Technical Service Information

THM 3T40 (125C) CONVERTER CLUTCH SHUDDER 1987 OR LATER ONLY

Figure 1

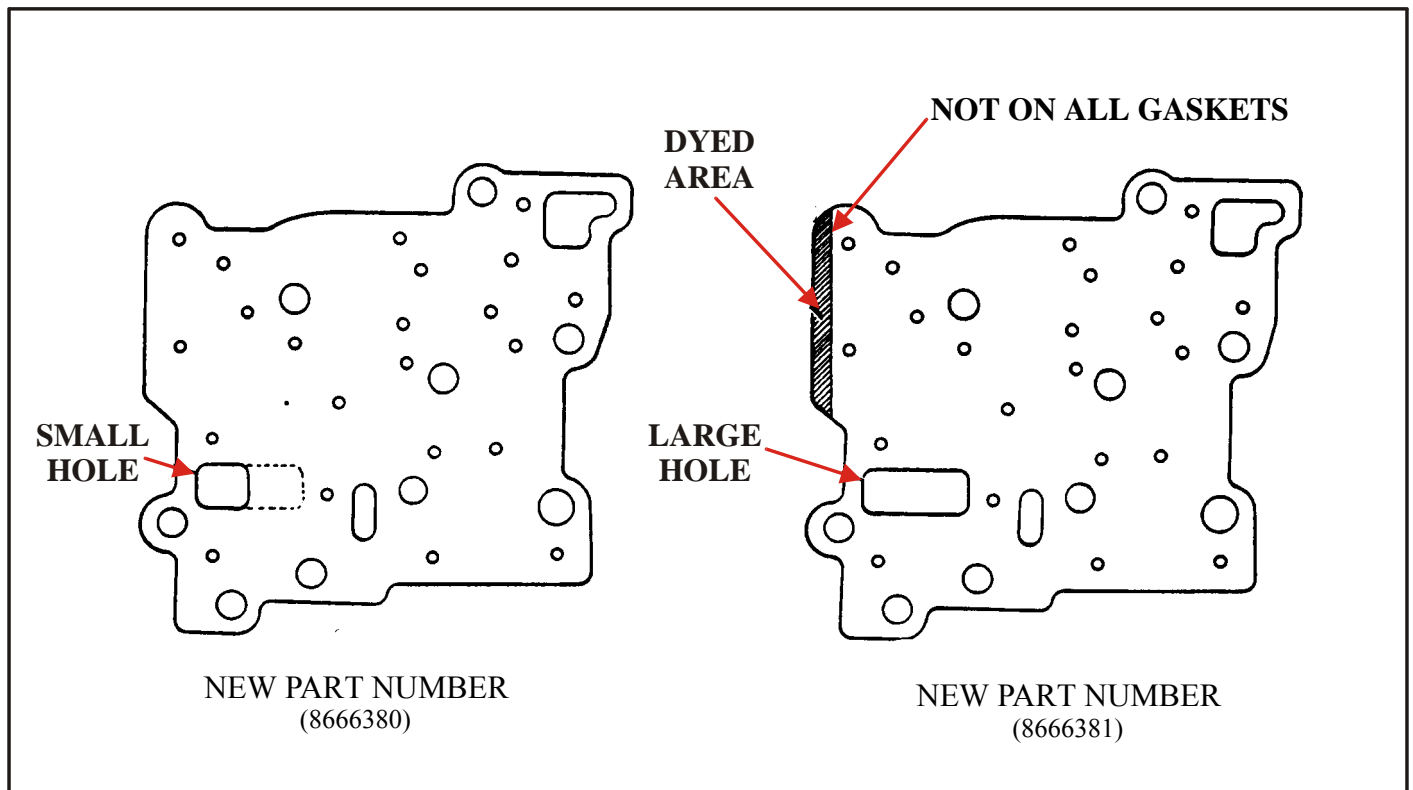
COMPLAINT: Converter clutch apply shudder, only on 1987 or late THM 125C (3T40) Transaxles.

CAUSE: Not enough converter clutch apply oil.

CORRECTION: Install the 1988 (KDC) auxilliary valve body gasket with the large hole (See Figure 1), or modify the 1987 gasket with the small hole, by cutting on the dotted line (See Figure 1).
